**COUNTY OF VENTURA
PUBLIC WORKS AGENCY**

MEMORANDUM

SUBJECT: **Piru Area Plan Amendment Technical Memo - Circulation / Lane restriping**

Figure 5.1 Mitigated Design Concept

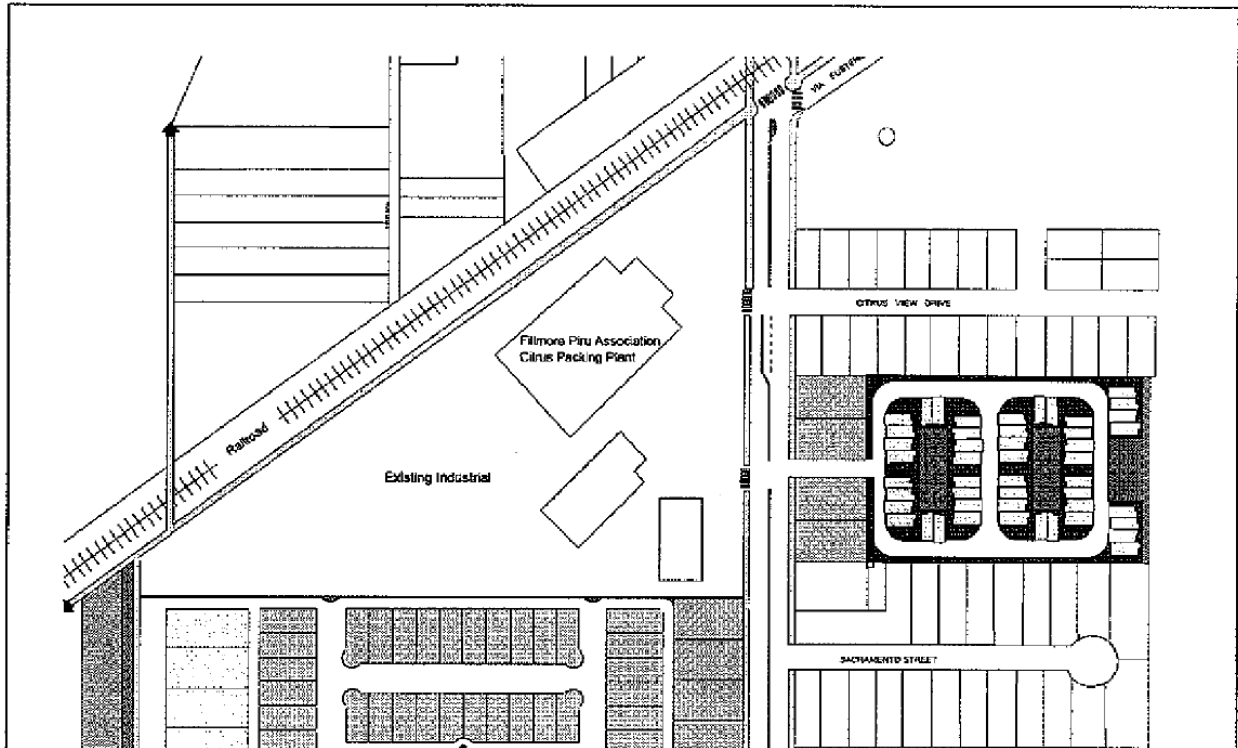
Proposed revisions to the Piru Area Plan, published as part of the Final EIR (Feb. 2006, pg. 71) includes the following revision to Transportation and Circulation Policy 4.1.2-3: At the Fillmore-Piru Citrus Association packing house, a left-turn lane shall be provided to facilitate truck access to the packing house. On-street parking at the packing plant should be eliminated and the multi-purpose pathway should be carefully designed with signage and pavement markings to minimize potential safety conflicts with packing house truck traffic. South of the intersection with Via Fustero, a landscaped median island shall be provided (Figure 14). Both of these features are shown in the figure above.

Based on the findings of our turning movement study, and the truck turning templates demonstrated above, PWA can support the request to remove the concrete median, center turn median and dedicated left turn pocket along the packing plant through the necessary revisions to the Piru Area Plan and EIR.

Below are before and after images of the access to the packing plant driveway:

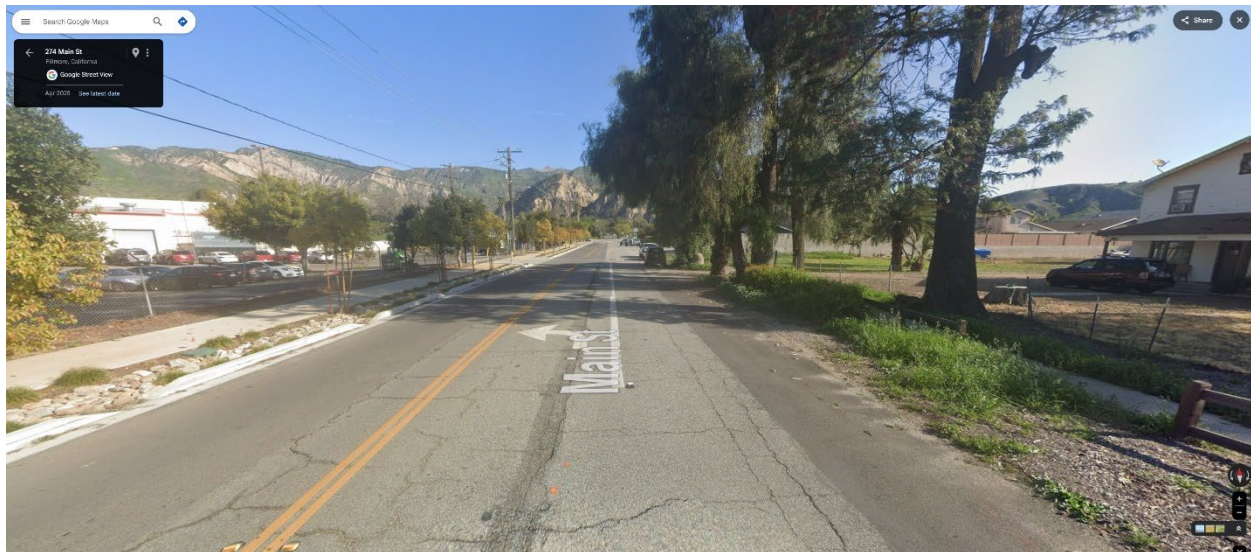
Trucks were found to be performing this maneuver of making a left turn by straddling the left turn lane and thru lane, or entirely from the thru lane because the location of the left turn pocket with respect to the relocated driveway entrance has reduced the turning radius from the street into the driveway, making a more difficult turn for the drivers. This maneuver also creates a safety issue: Due to the tight turning radius, the back end of trucks making a left from the turn pocket sometimes swing into the northbound through lane creating a potential conflict for vehicles trying to pass turning trucks.

Figure P-21 Intersection Enhancements at Main Street and Via Fustero

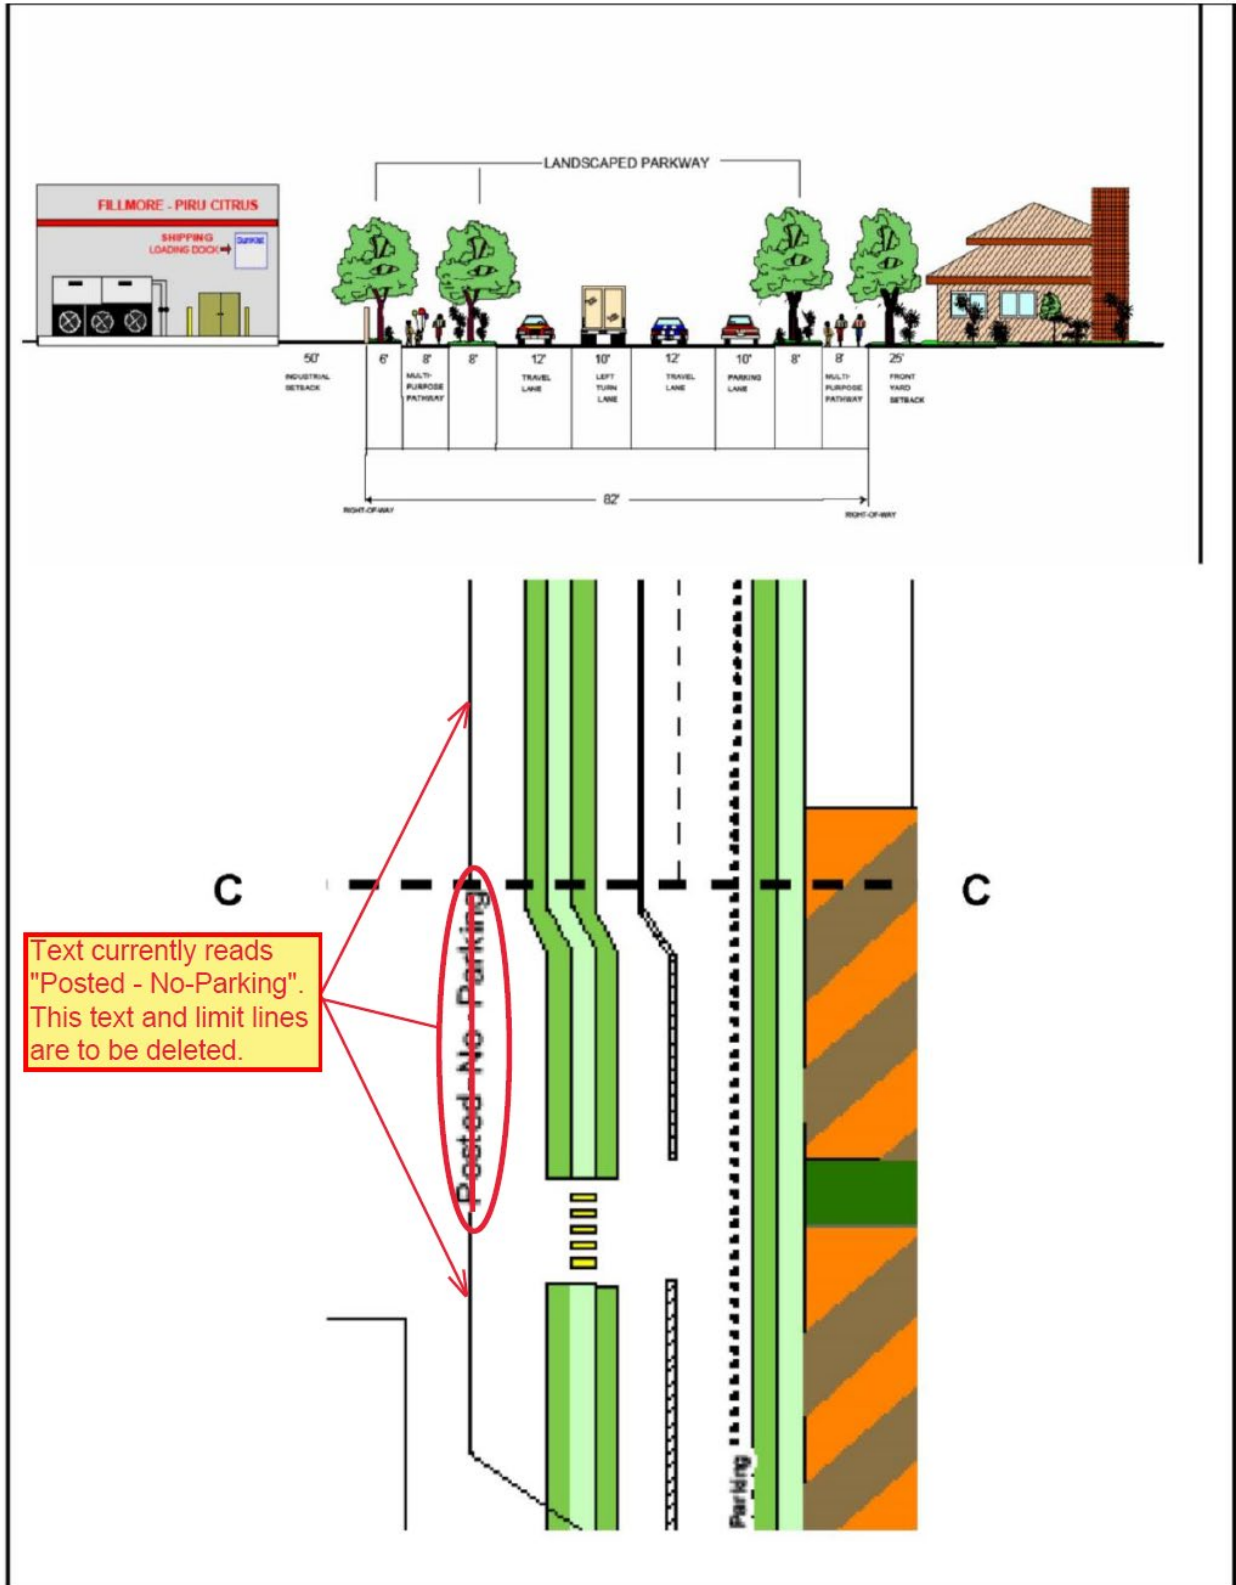
Below are revised Table P-6 (Description of Proposed Circulation Improvements), Figure P-17 (Main Street Concept Plan), Figure P-20 (Enhanced Main Street – Cross Section “C”) and Figure P-21 (Intersection Enhancements at Main Street and Via Fustero) demonstrating the conditions should removal of the concrete median, left turn lane, and striped “center turn median” be approved.
